CITY OF UNLEY
COUNCIL ASSESSMENT PANEL

20 June 2023

ITEM 1**DEVELOPMENT APPLICATION - 22039582 – 91 KENILWORTH ROAD, PARKSIDE SA 5063**

DEVELOPMENT APPLICATION - 22039582 – 91 KENILWORTH ROAD, PARKSIDE SA 5063

SIDE ELEVATION
 Scale 1:50 @ A3

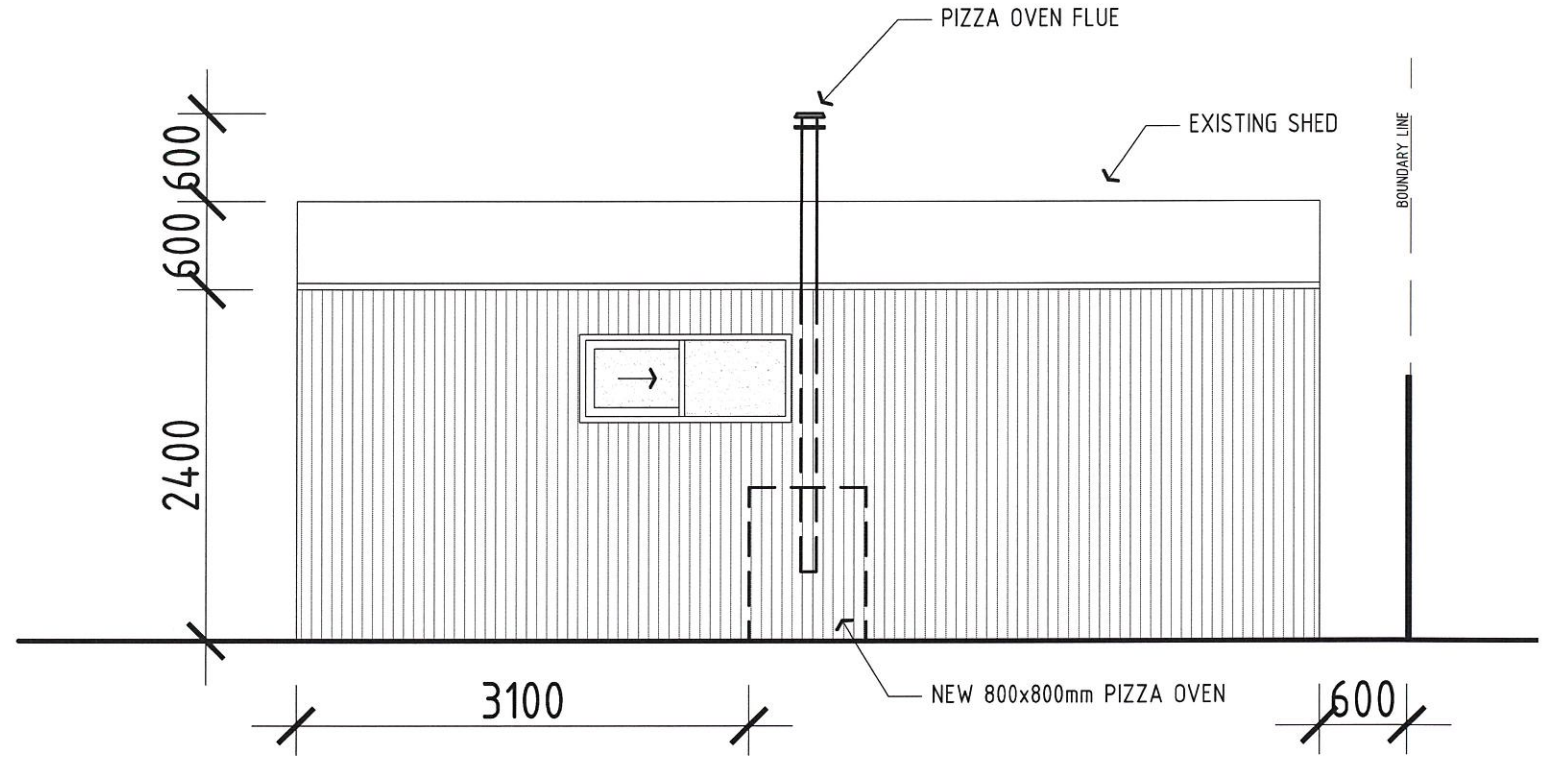
The proposal seeks to install a flue from a pizza oven on the southern side of the existing outbuilding. The flue will extend through the roof of the outbuilding and sited 600mm above the pitch of the roof. A copy of the plans is contained in **Attachment 1**.

1. Flue has now been moved to satisfy requirements of the planning and Design code(see attached diagram).
2. Pizza oven is operated only on very few occasions during the year, which is not more than once a month at most (and most definitely not every weekend).
3. Neighbours alongside and behind the property of 91 kenilworth road, operated a bbq which they cook meat on most weeks and no complaint has ever been lodged, in regards to smoke and odour.
4. Please note most if not all 'reasons' have now been adhered to.

Figure 6: Extract from application plans prepared by Girardi Design detailing the elevation of the proposed dwelling upon Lot 1

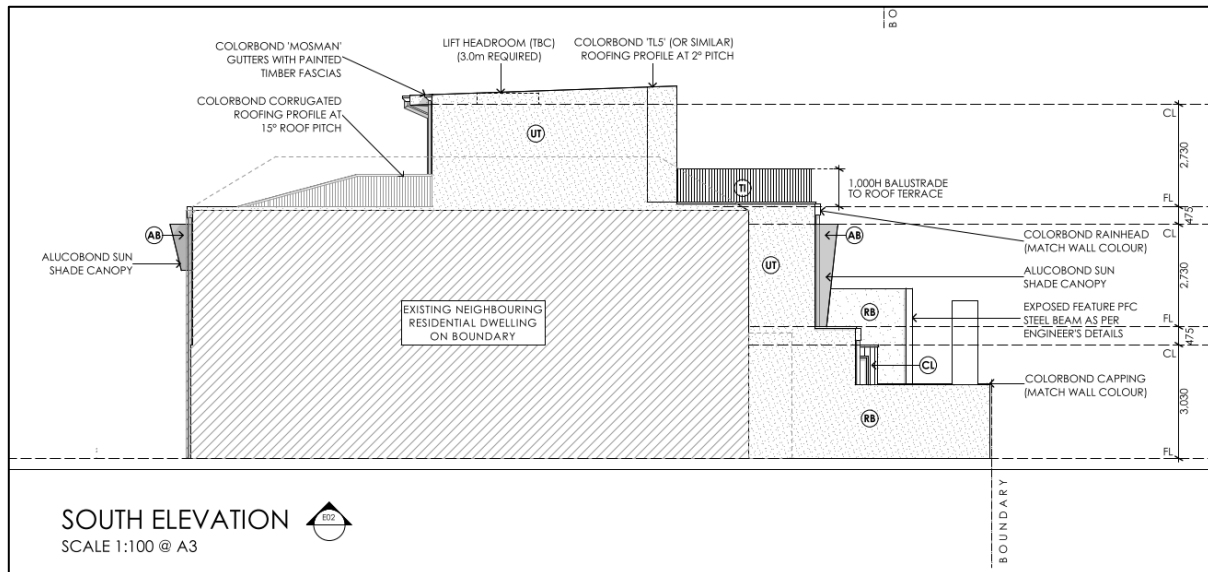
Given the inset of each building level, the bulk and scale of the building as viewed from the primary street will be reduced, with particular regard to the third level which will be largely obscured at eye level as viewed from the public realm.

Figure 7: Extract from application plans prepared by Girardi Design detailing the level of overshadowing from the proposed dwellings. Location of boundary walls shown in red.

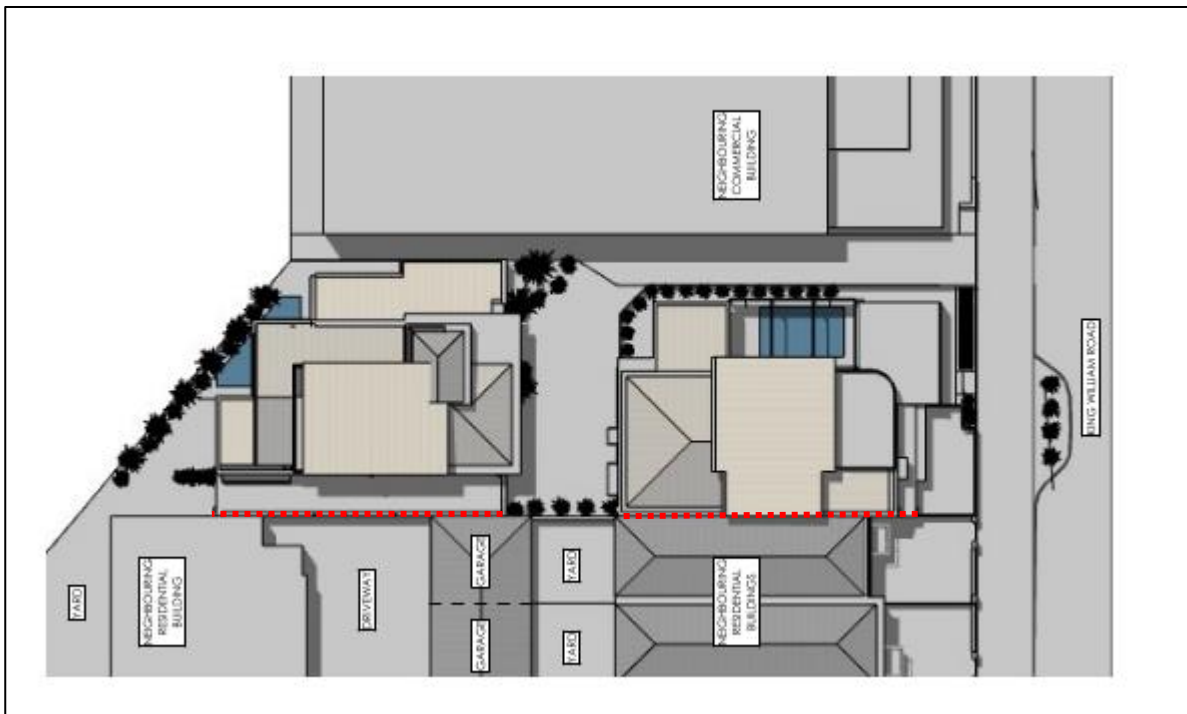
The proposed boundary walls for each dwelling have been sited to align with the existing boundary walling of the dwellings to the south and the shared driveway which services the dwellings. This can be seen within the image below:

PO 3.1 & 3.2 of the **Interface between Land Uses** section states that overshadowing of habitable room windows of adjacent residential land uses and private open space areas of such land uses be designed to allow for the following:

- *'North-facing windows of habitable rooms of adjacent residential land uses in a neighbourhood-type zone receive at least 3 hours of direct sunlight between 9.00am and 3.00pm on 21 June.'*
- *'Development maintains 2 hours of direct sunlight between 9.00 am and 3.00 pm on 21 June to adjacent residential land uses in a neighbourhood-type zone in accordance Overshadowing diagrams have been provided which detail the level of overshadowing of the proposal from June 22 – 9am to 3pm (winter) and December 22 – 9am to 3pm (summer).'*

FIGURE 2.8 CIRCULATION ROADWAY AND RAMP CROSS SECTIONS

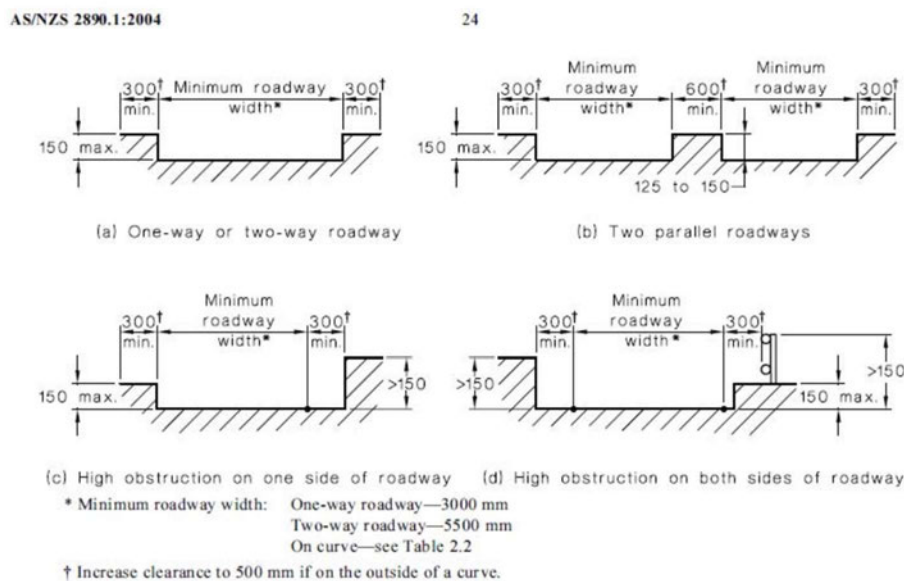
While this driveway width was accepted by Council at the time of determining the development on your land due to the limited increase in vehicles movements arising, it does not have capacity to accommodate the proposed development.

If this residential development is to proceed, this driveway will need to be provided with additional width to allow for simultaneous two way movement. At a minimum, structures should be set back 300 mm either side as per the detail below, as you have on your side.

FIGURE 3.3 MINIMUM SIGHT LINES FOR PEDESTRIAN SAFETY

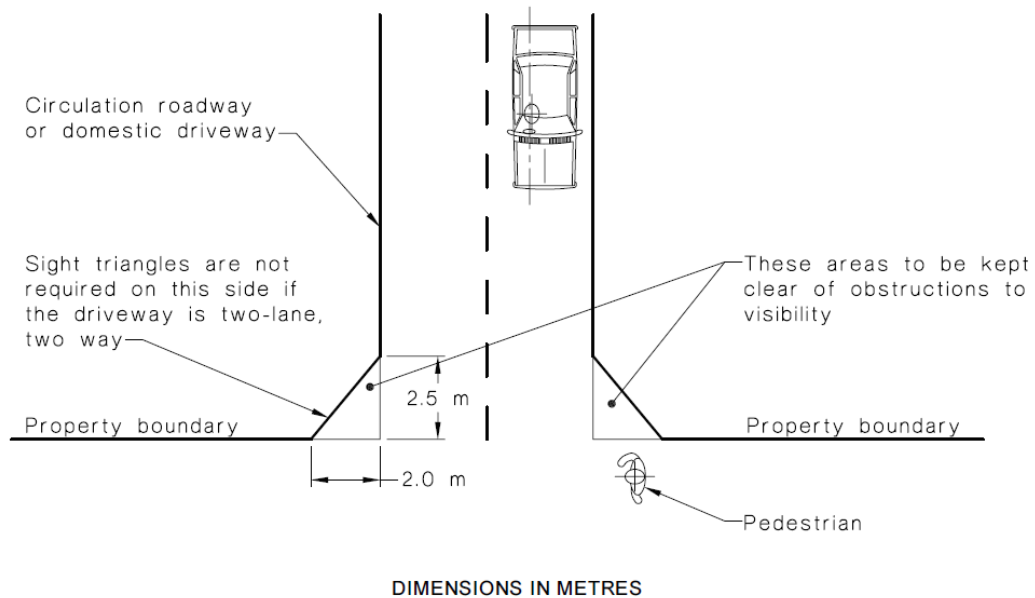
- Pedestrian safety along ROW when vehicles are also utilizing the ROW. Please note that the shared ROW / Driveway is a low speed shared zone, with vehicles and pedestrians required to give way as required. The ROW is at least 3m wide, which provides adequate width for a pedestrian to safely pass a vehicle utilizing the ROW at the same time.
- Traffic Safety at the shared junction between Dental Surgery and residential properties (i.e. multiple vehicles exiting the ROW at the same time). Please note that all vehicles will be exiting the site via the ROW in a forward's direction, which will provide far superior sight lines compared to a reversing vehicle. Like most road junctions, the vehicle arriving first would typically have right of way with the other vehicle giving way. This type of arrangement does not represent a significant safety concern that requires additional action.

In addition, it was advised that clear sight distance for pedestrians should be provided in the form of a pedestrian sight triangle. This has since been implemented within the latest set of plans.
